SUBJECT: UNIVERSITY OF MARYLAND - REQUEST FOR ADDITIONAL
INFORMATION RE: FOR THE RENEWAL OF FACILITY OPERATING LICENSE NO. R-
70 THE MARYLAND UNIVERSITY TRAINING REACTOR DOCKET NO. 50-166

Enclosed please find the responses to RAIs #1, 2, 4, 29, 31, 40, 44, 58-61 dated July 28, 2016 for the University of Maryland Training Reactor (MUTR).

Technical Specifications

License No. R-70, Docket No. 50-166

Figure 6.1: Position Chart

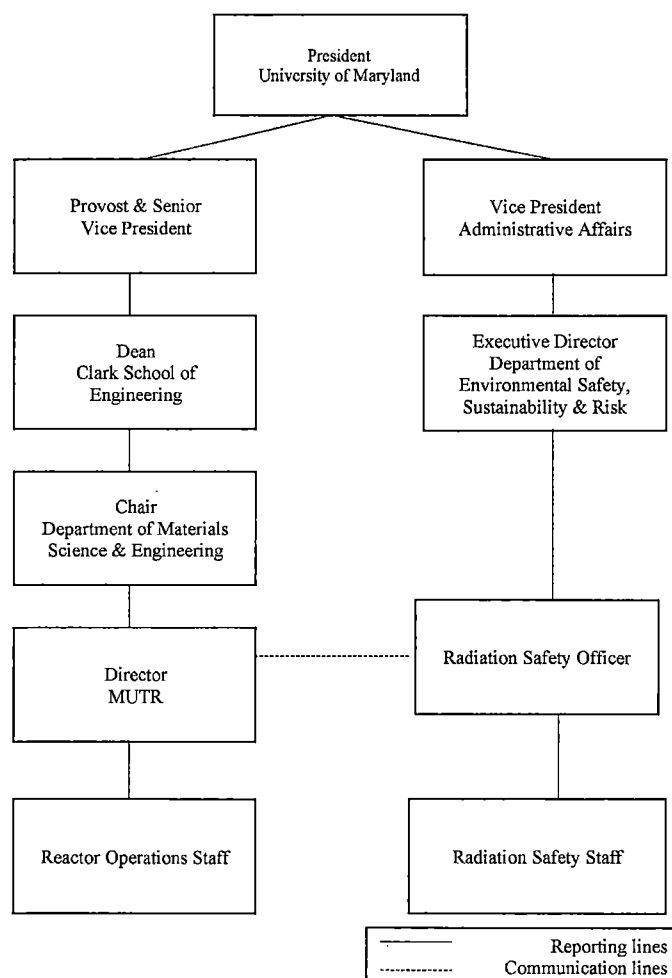
- 44. Revise TS 6.1.1, Figure 1 to clarify the current name for the Department of Environmental Safety, or justify why no change is necessary.

The figure has been revised to reflect the current name for the Department of Environmental, Safety, Sustainability and Risk.
